CASE #PL2020-112

MINNESOTA
CAMPUS PARKING
RAMP

Name
Date 07-08-2020 Lic./Reg. No. 53706
Issued For
Item Date
CITY SUBMITTAL 07-08-2020

LANDSCAPE PLAN

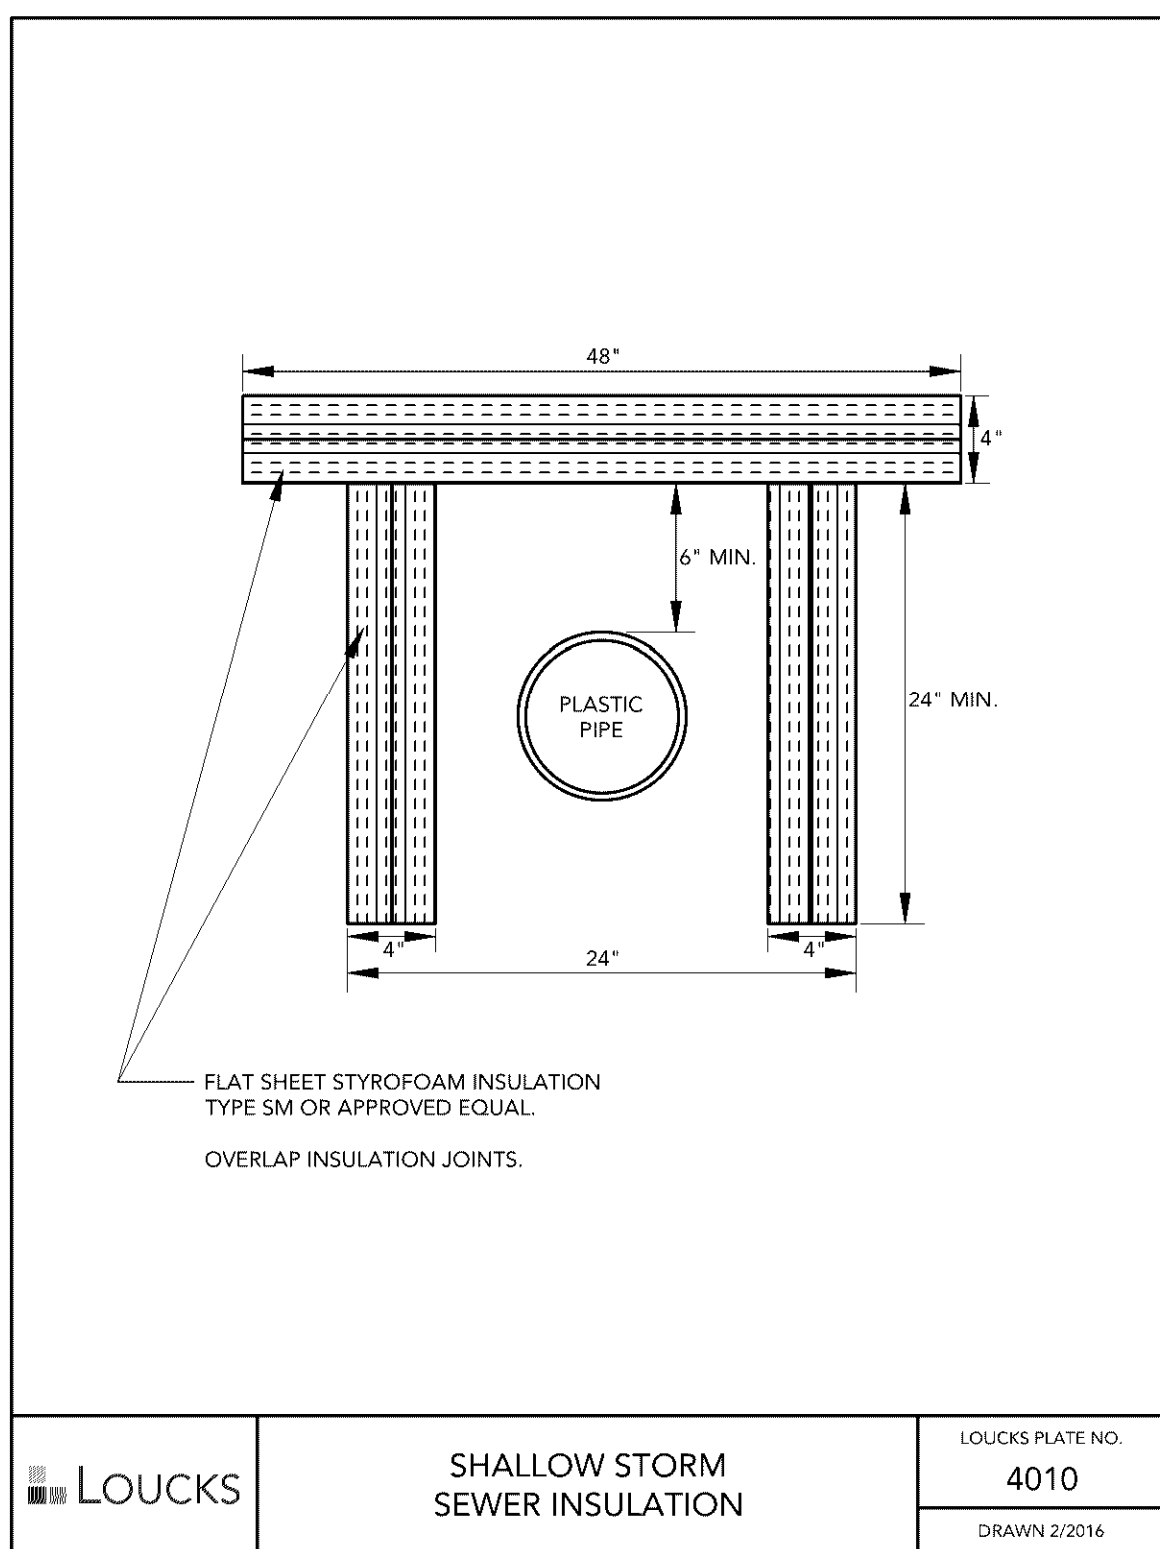
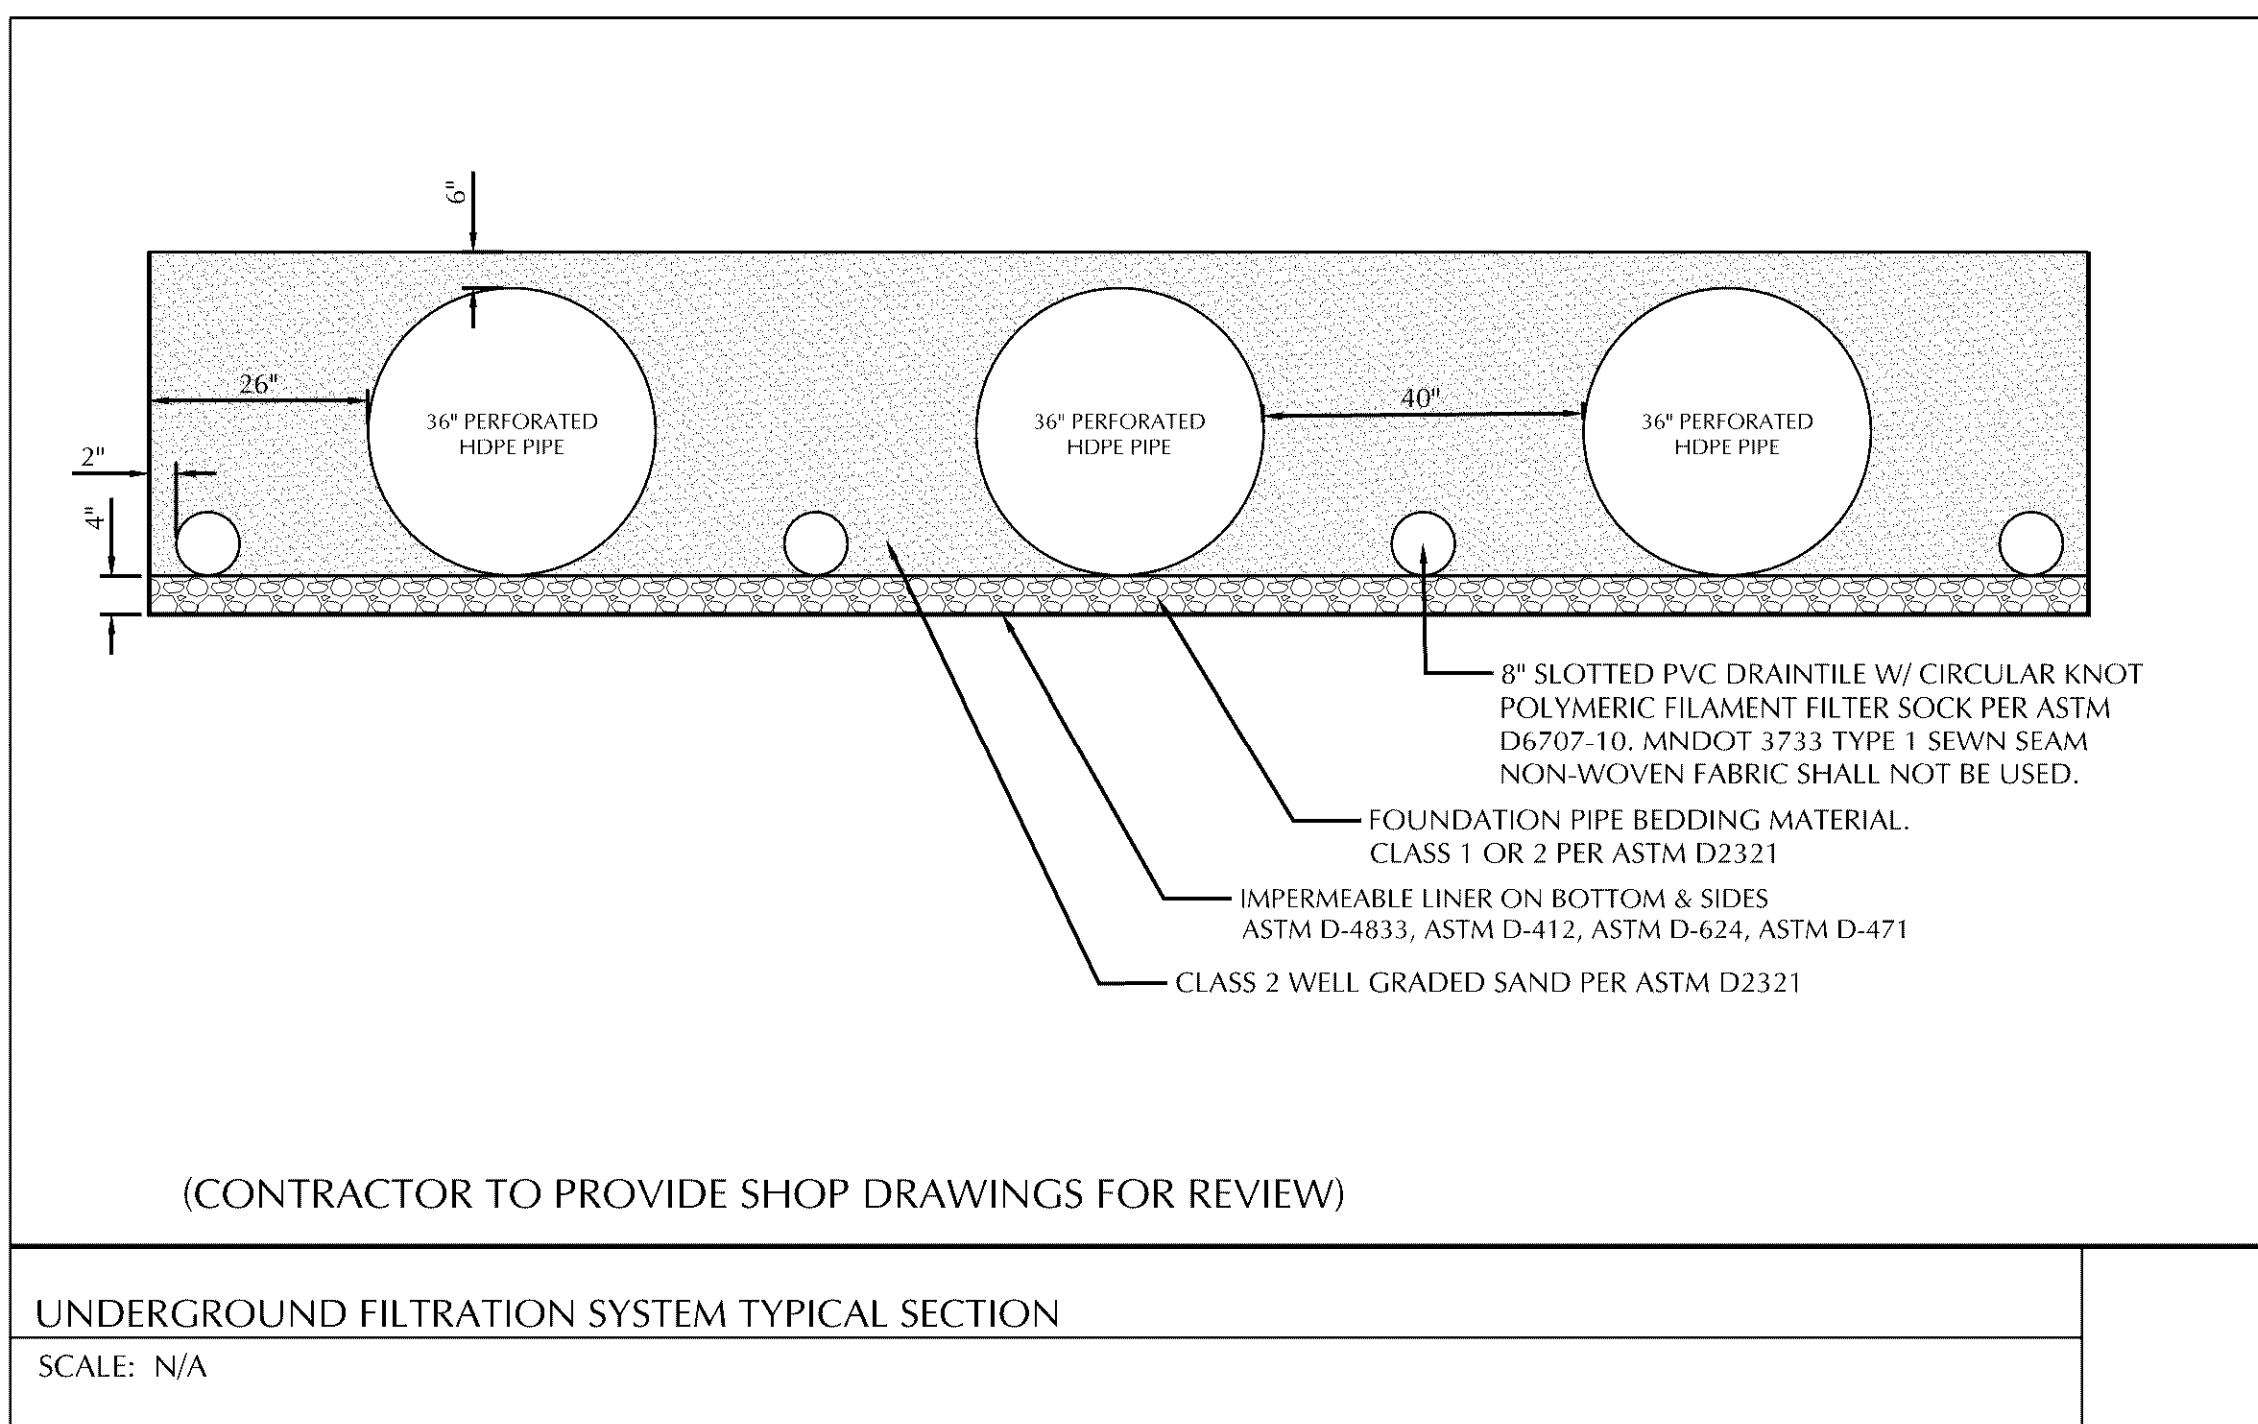
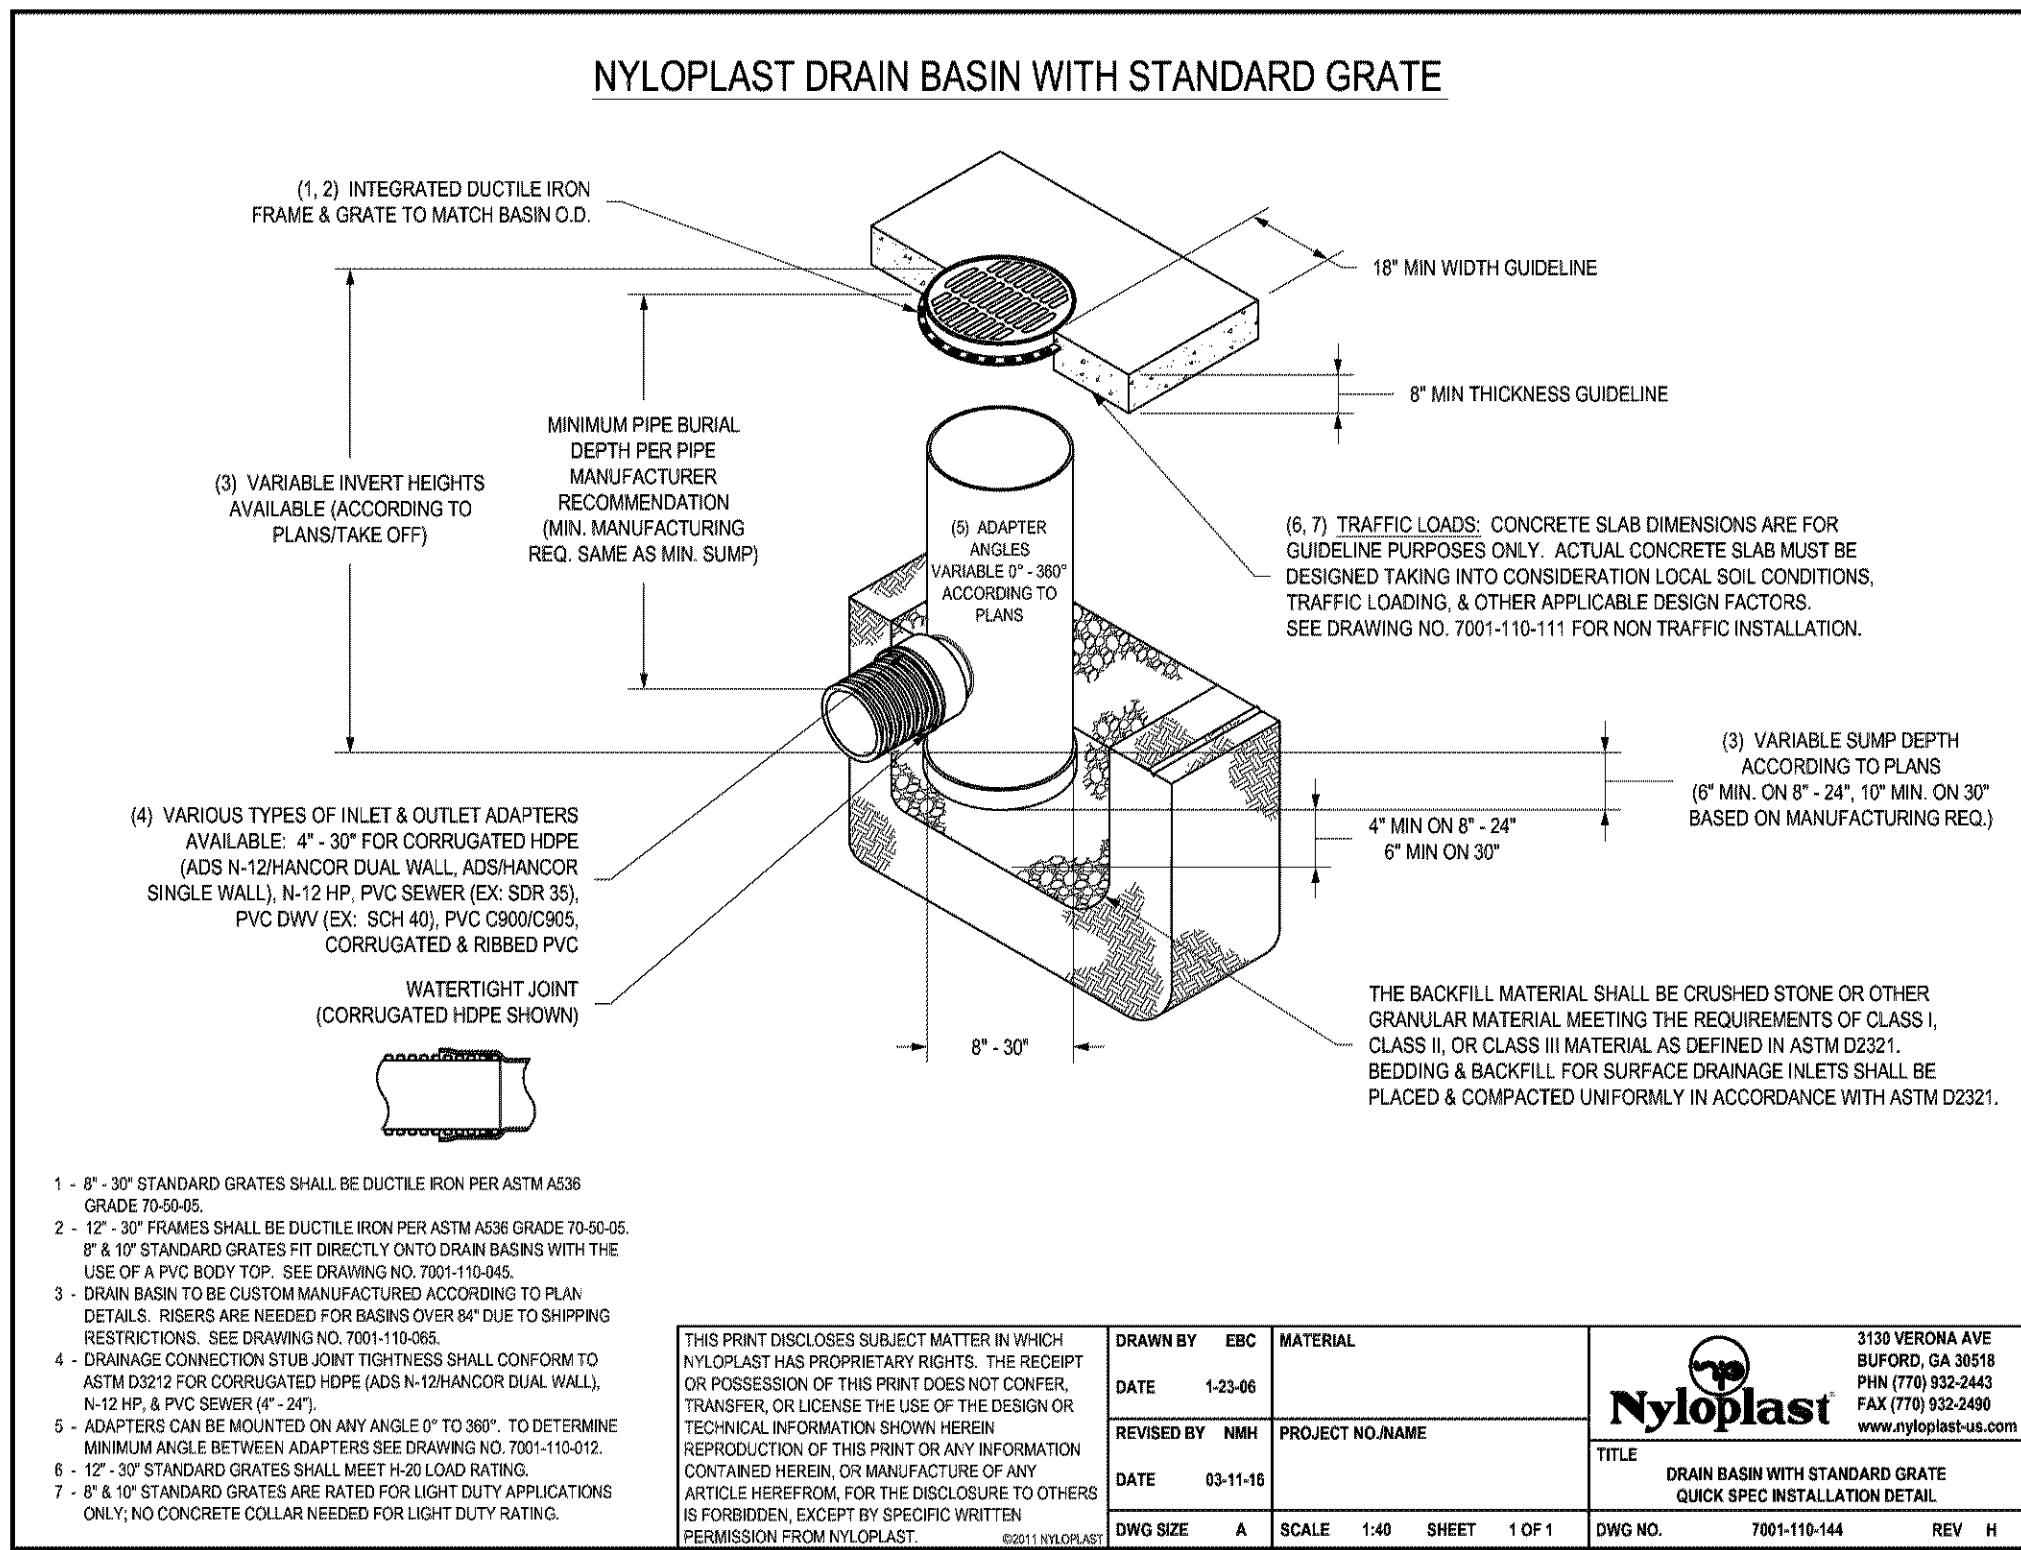
Development Landscaping Area would include all areas of site disturbance if the base material is replaced or disturbed. Please verify mill and overlay areas do not include disturbance of base material.

Based upon the development landscape area provided, the landscape plan is deficient by 19 trees based upon required landscaping and proposed removals. An updated landscape plan with 110 trees must be provided.
